MIL-C-28840A(EC)
AMENDMENT 4
01 April 1993
SUPERSEDING
AMENDMENT 3
25 JUNE 1984

CONNECTORS, ELECTRICAL, CIRCULAR THREADED, HIGH DENSITY,
HIGH SHOCK SHIPBOARD, CLASS D
GENERAL SPECIFICATION FOR

This amendment forms a part of MIL-C-28840A(EC), dated 26 May 1981, and is approved for use by the Space and Naval Warfare Systems Command, Department of the Navy, and is available for use by all Departments and Agencies of the Department of Defense.

FIGURE 5. Connector, receptacle, electrical, interface dimensions."

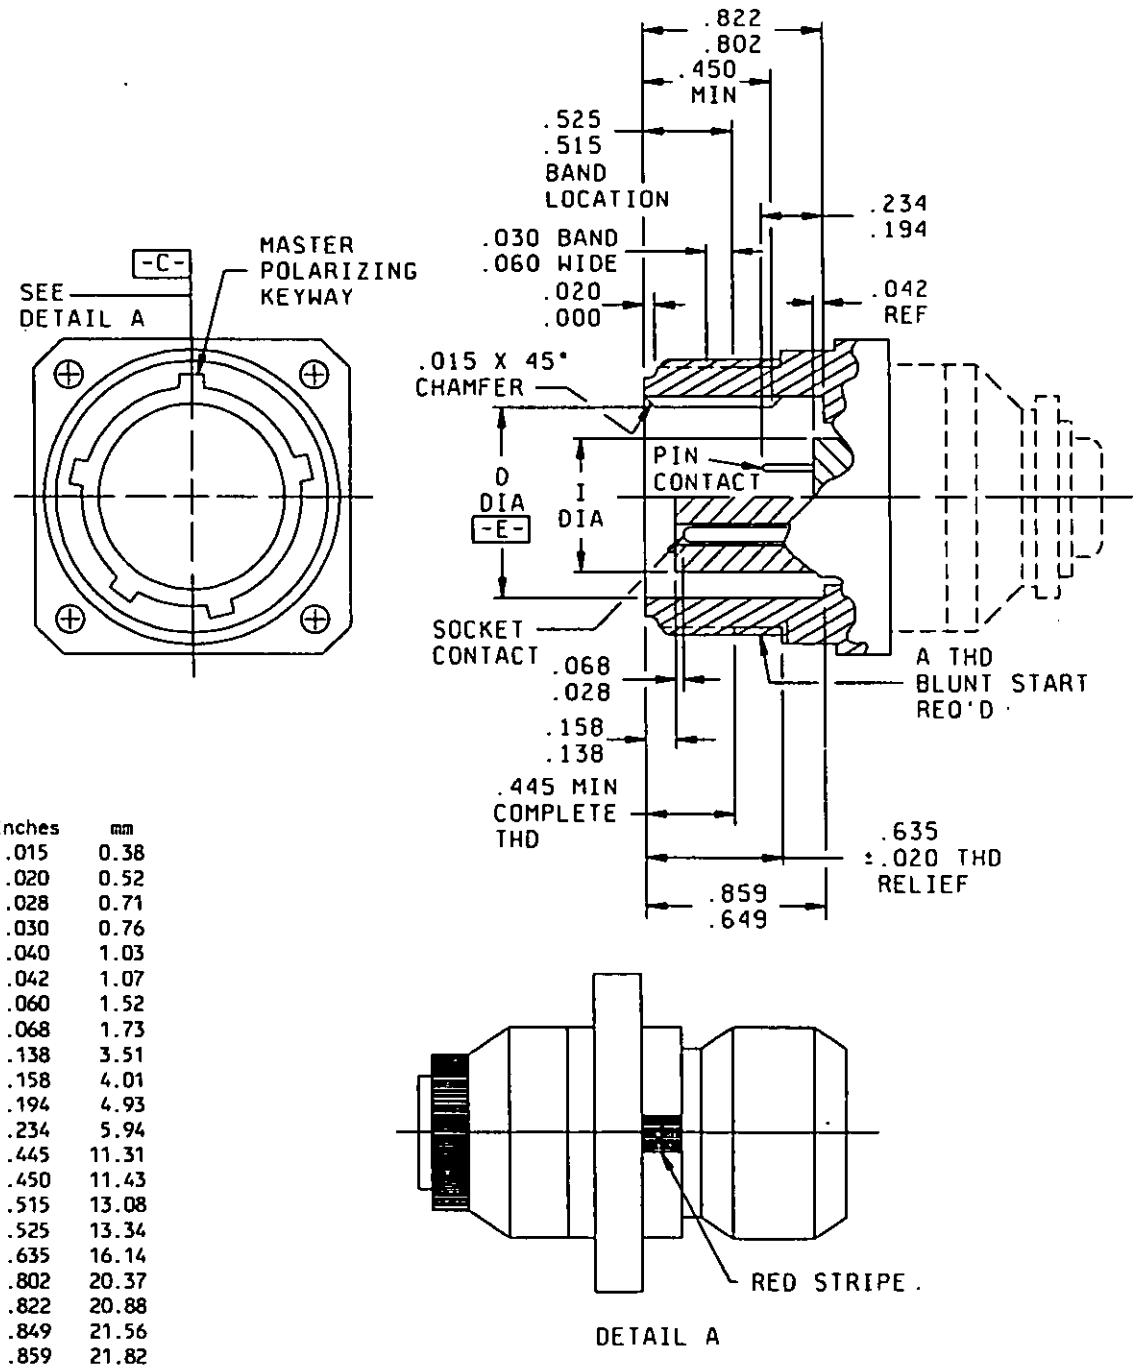
* FIGURE 5, delete and substitute:

"3.26.1.5 Receptacle shell. The receptacle shell shall be marked with a red stripe directly above the master keyway to help align the plug and receptacle prior to mating as shown on figure 5. A red band shall also be placed on the shell in such a manner that it will just be covered by the coupling ring when the connector is fully mated to insure a full mate. The location of the fully mated indicator band and master polarizing keyway stripe shall be as shown on figure 5."

FIGURE 10. External bending moment test set-up. "

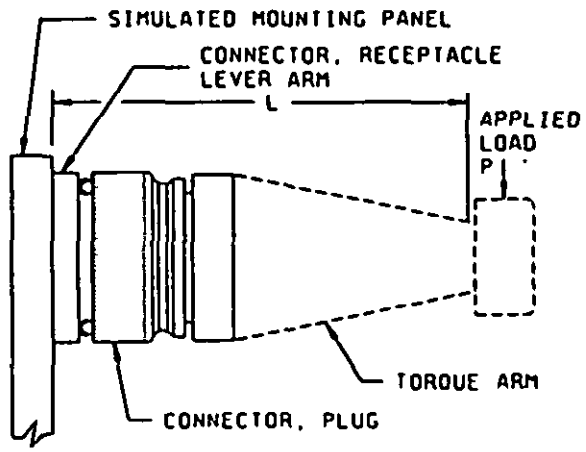
* FIGURE 10, delete and substitute:

"4.6.17 External bending moment (see 3.21). The receptacle connector shall be mounted as in normal service to a rigid panel. Before mating the plug connector to the receptacle, an adaptor or test torque arm shall be attached as shown on figure 10. After mating the plug and receptacle connectors, the distance "L" from the point of load application "P" to the mounting panel shall be determined. The load shall be applied at point "P" and shall then be determined as the bending moment listed in table XII, divided by the level arm "L". This load shall be applied at a rate of approximately 10 pounds per second until the required load is achieved. The applied load shall be held for 1 minute, then the load shall be released."

FIGURE 14. Test gauge, pin, gauge location, and retention."

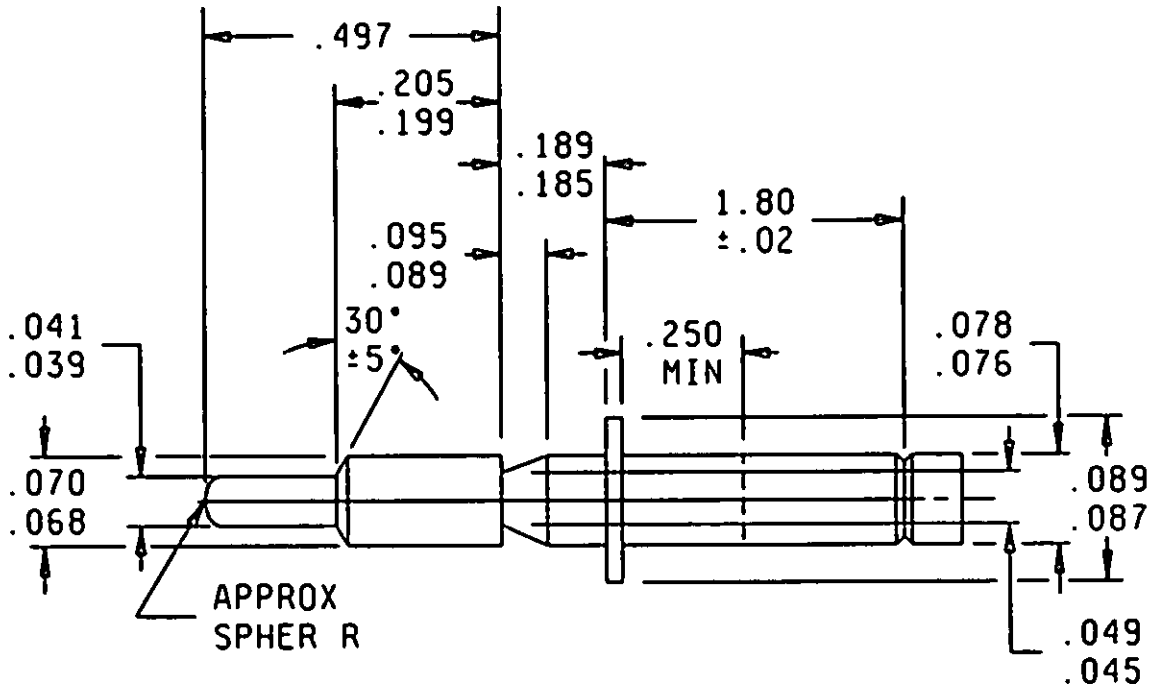
FIGURE 14: Delete and substitute new figure 14.

NOTES:
1. Material: Hardened tool steel.
2. Finish: 32 microinch polished.
3. Design of rear extension is optional, but must have a groove provided as indicated.
4. Dimensions are in inches.
5. Metric equivalents are given for information only.
6. All diameters concentric to each other within a .004 TIR.
